Attachment 11: July 24, 2008 WALKSacramento Comment Letter

P08-066 Natomas Central School Site Rezone

WALK Sacramento alternative
7/23/08

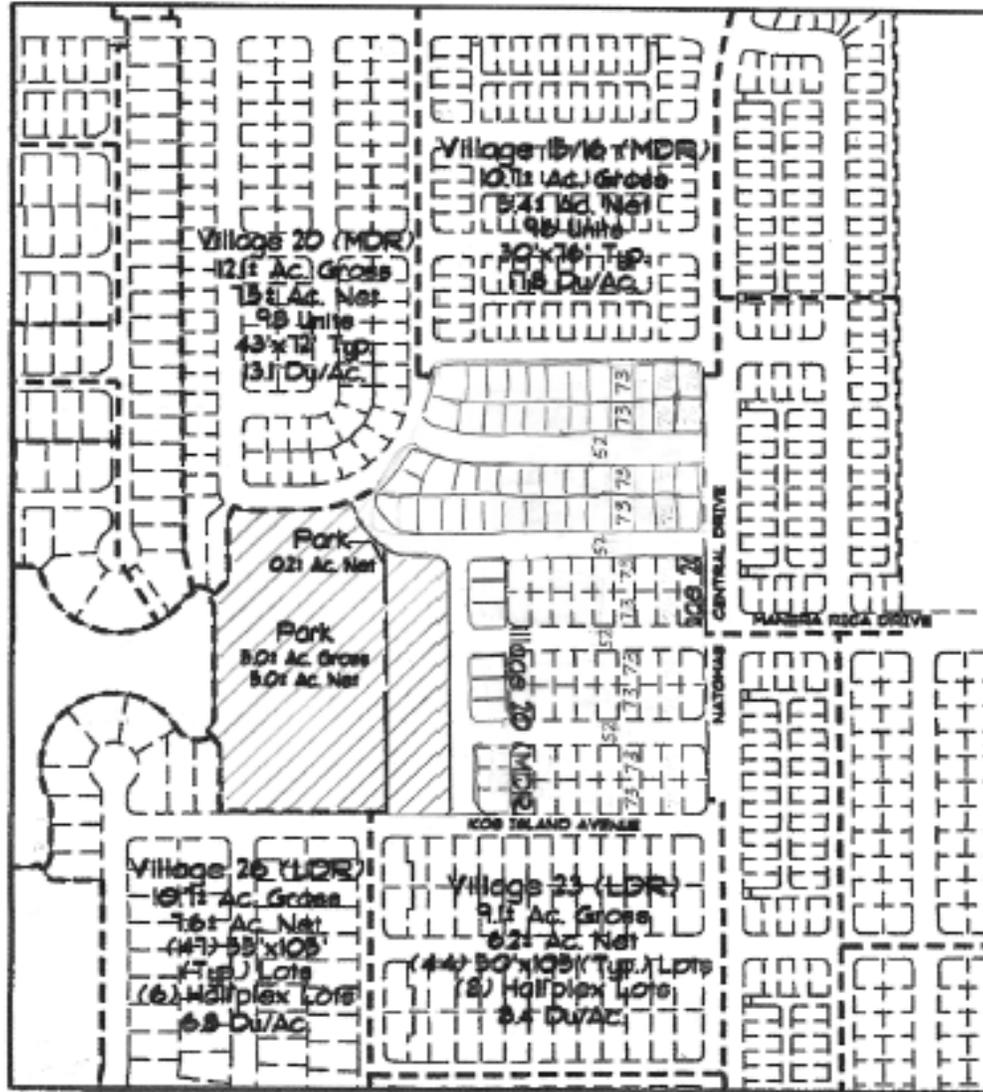
9. **Reconfigure the tentative subdivision map to provide a conventional grid street system.** Improvements include greater mobility for pedestrians and motorists, the potential for dual or single curb ramps at every intersection, better access to the park and lake, separated sidewalks on all streets, more street connections to Natomas Central Drive, and no dead-end streets.

A modified tentative subdivision map, WALKSacramento alternative 2, is included at the end of this letter. All lot depths are 73' except for those on the west end of the blocks, and all interior street rights-of-way are 52' wide. We suggest modifying the standard 53' residential street cross-section by reducing the curb-to-curb width by one foot or reducing each of the planter widths by six inches to provide a 52' ROW.
